**BEFORE THE HEARINGS PANEL
FOR THE QUEENSTOWN LAKES PROPOSED DISTRICT PLAN**

IN THE MATTER of Hearing Streams 17
and 18 –
Stage 3 and 3b
Proposed District Plan

**REPLY OF MATTHEW STUART BENTLEY JONES
ON BEHALF OF QUEENSTOWN LAKES DISTRICT COUNCIL**

LANDSCAPE – REZONINGS

Figure 1: The section of State Highway 6 where the site is visible, north of the site. Source: <http://qldc.maps.arcgis.com>. Note, not to scale.

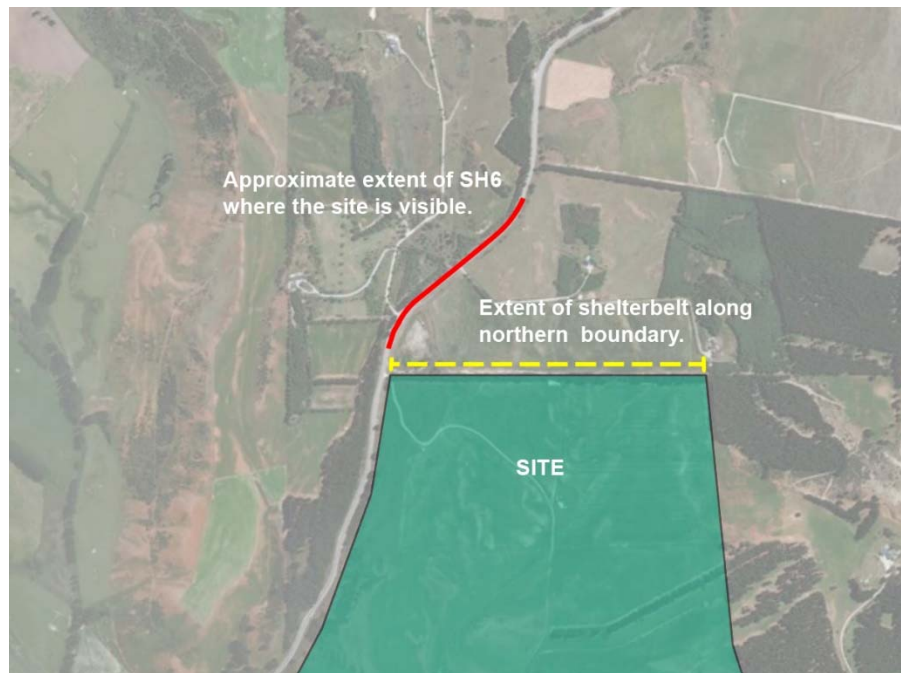
- 6.7** However, when travelling south along State Highway 6 from Lake Hawea, the road (proximate to the site) is at a similar contour to the upper terrace. This stretch of road is approximately 400m long and for a section provides direct views toward the site (refer Figure 1 below). The existing shelter belt which extends along the northern boundary of the site currently provides a buffer and screening of the site. In my opinion, this shelterbelt should be maintained and included in the relevant planning provisions in order to provide a level of surety to mitigating any potential adverse visual amenity effects from future buildings (when viewing from the north). Ms Grace and I have discussed the mechanism for the implementation to 'maintain' this shelterbelt along the northern boundary and this is reflected in planning provisions appended to the Reply Statement of Ms Grace.

6.8 Having reviewed the Development Plan and the detail associated with the respective activity areas and planning provisions, I change the assessment conclusion reached at paragraph 3.12 of my rebuttal evidence and now **do not oppose** the rezoning relief sought for this site, **subject to** the addition of the maintaining the shelterbelt along the northern boundary of the site. The proposal will result in an acceptable outcome that will serve to maintain the landscape character and visual amenity values of the RCL.

Upper Clutha Transport – Church Road Topographic & Cross Section Plan

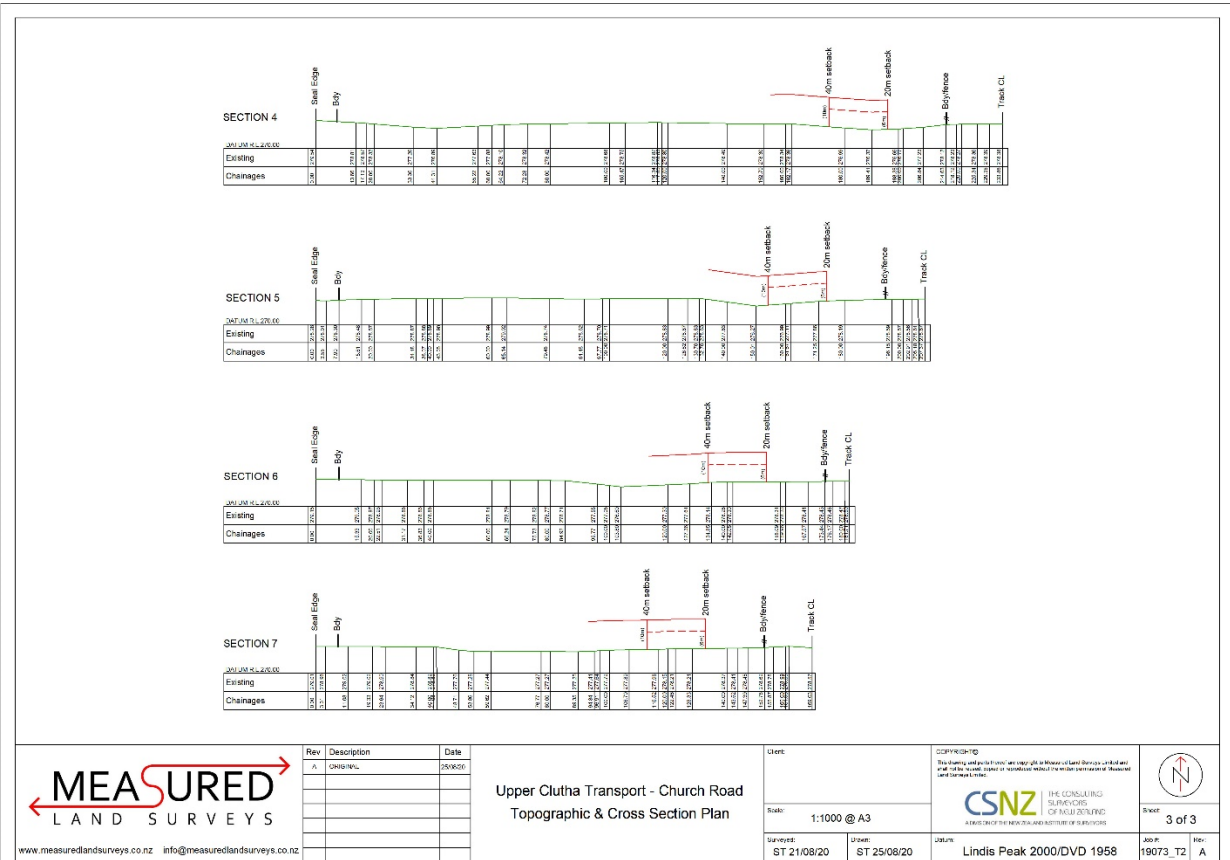
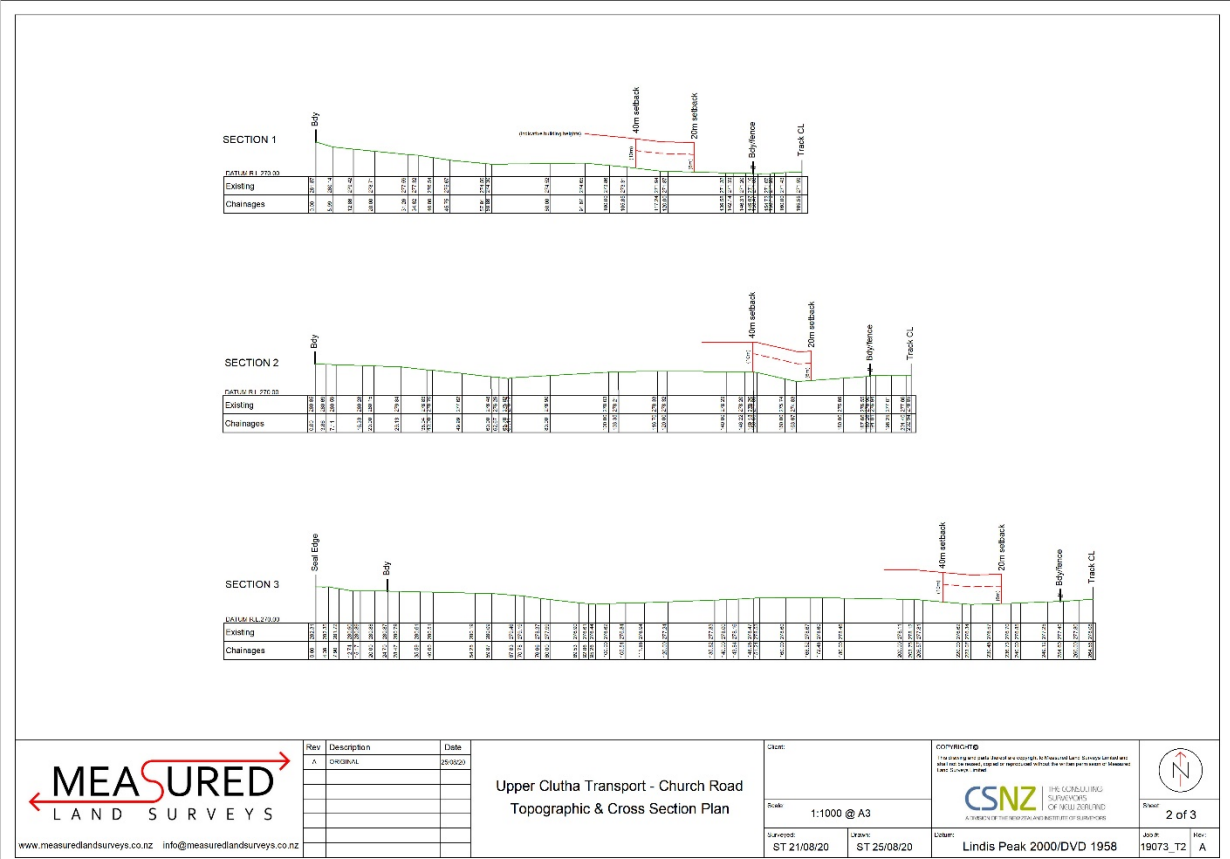
- 2.3 I walked along the Upper Clutha River Track, which is essentially at the same relative contour level adjacent to the site. From this location, along this public track, I confirm, in relation to 6.3.4.6(a), that the site will be highly visible and that visual mitigation and a Building Restriction Area (**BRA**) would be required along the site’s northern, eastern and southern boundaries in order to avoid adverse effects on visual amenity resulting from potential future development.

2.5 The submitter supplied topographical maps and cross sections through the site³, 'Structure Plan' layout options⁴ and revisions to planning provisions which sought to address the potential effects from a landscape and visual perspective. The information provided assisted in understanding the nature of the site, any potential effects and subsequently the opportunities for mitigation.

Structure Plan - Church Road Rural Industrial Zone

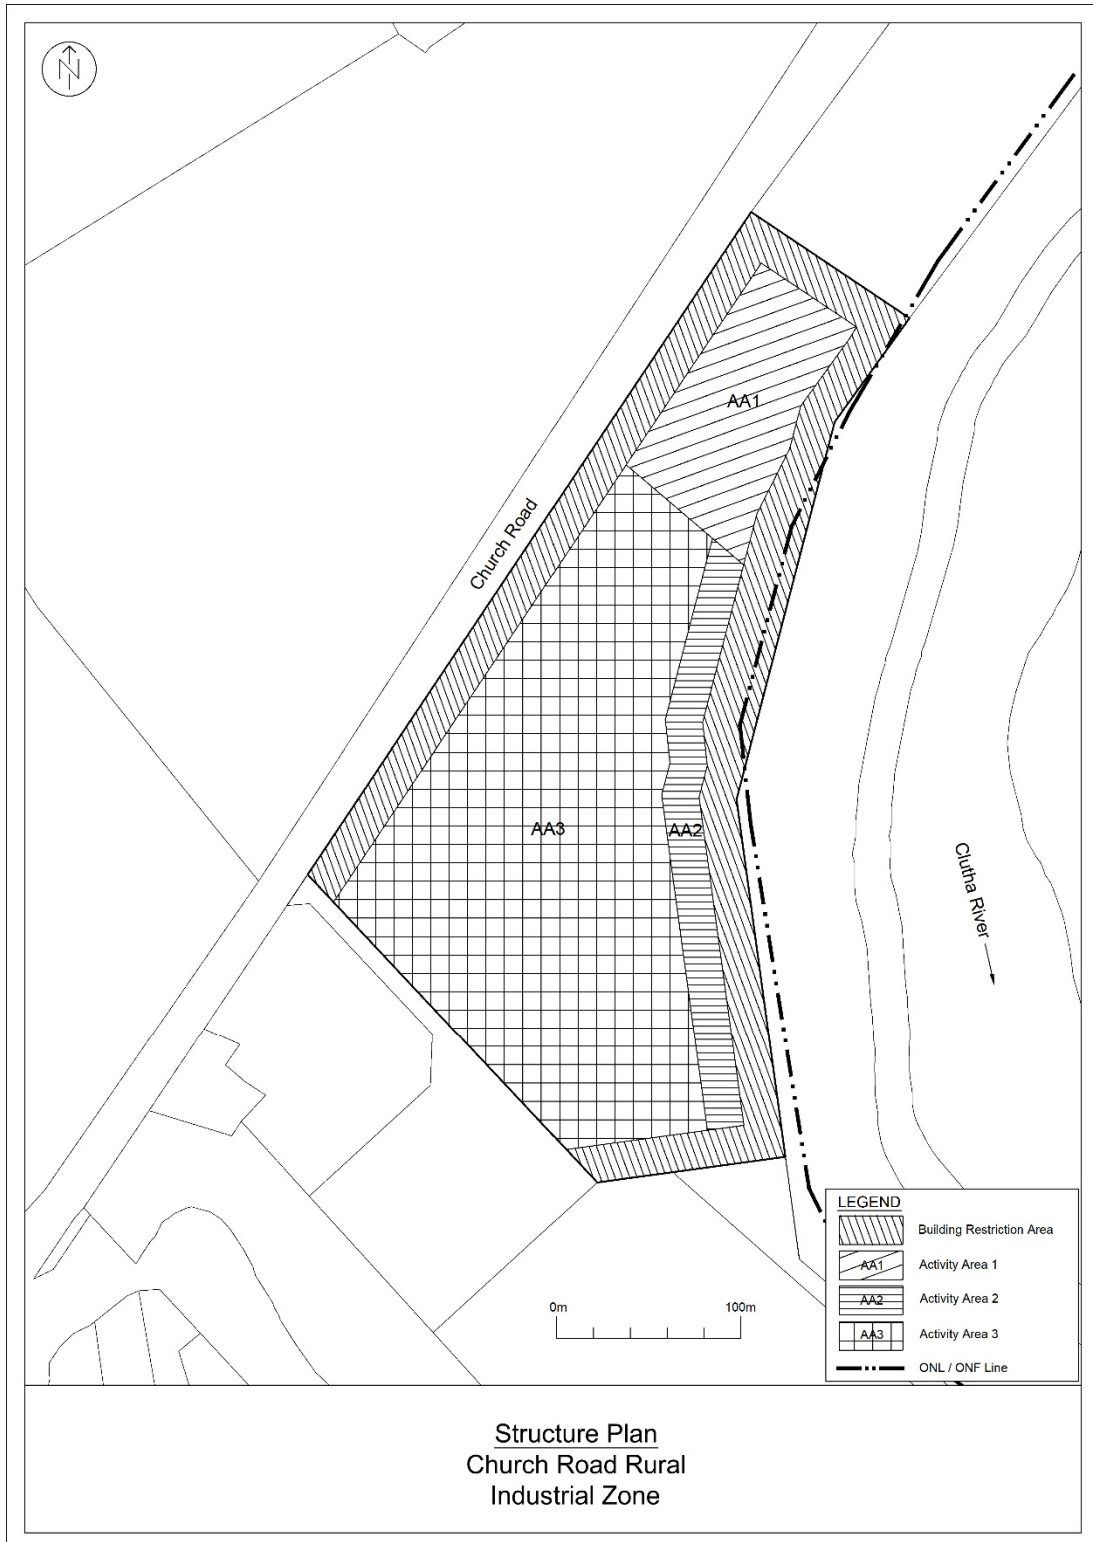
- (a) The BRA setback along the eastern boundary (extending from the southern boundary north to Activity Area 1 – AA1) should be widened to 40m (the submission originally proposed a setback 20m⁵). The setback should be measured from the ONF line where it is located within the boundary of the site or the site boundary, whichever is further west⁶;
- (b) To the west of this BRA setback, a 10m wide strip to be included (Activity Area 2 – AA2) with a maximum building height of 6m. This strip extends adjacent to Activity Area 3 (AA3) north to AA1. The 6m maximum height ensures a 'step' in building height to AA3, which has a maximum building height of 10m;

Please note that this Structure Plan appended does not represent agreement with the submitter or those matters which I outline within **paragraph 2.7**. It is purely a plan supplied by the submitter which illustrates what they sought to achieve and also shows the activity areas across the site.

- (c) Along the eastern and northern boundaries (adjacent to AA1 within the northern part of the site) the BRA should be at least 20m wide;
- (d) A 20m BRA and 10m wide AA2 area to be provided along the southern boundary;
- (e) A 20m BRA is retained along the western boundary with Church Road; and
- (f) Comprehensive landscape planting treatment is provided within the BRA areas. This is to include vegetation that can grow to a height that will significantly screen future built form within the site when viewing from the north and east, and visual softening when viewing from the west.

Difference between Existing Rural Residential & Proposed Settlement Zone Plan

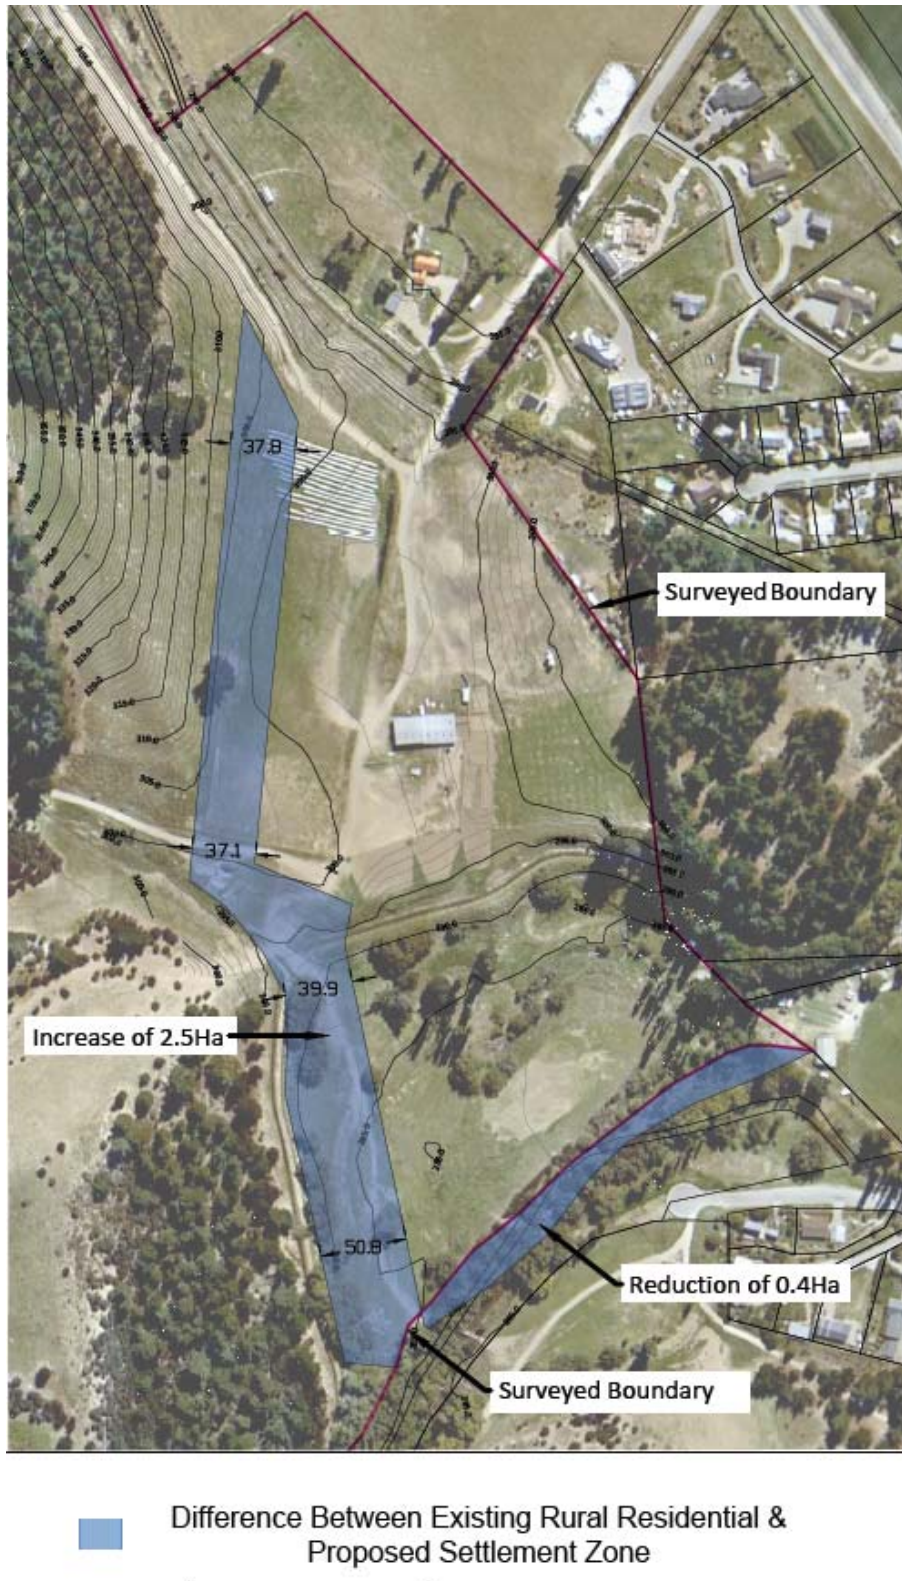
- 4.1 During the Hearing the Panel sought confirmation of the width of the 'blue strip' on the left (western) boundary of the site as illustrated in Appendix 1 of my EiC. This width varies along its extent between 37.1m and 50.8m. This is illustrated on the plan attached to this reply at **Appendix C**.
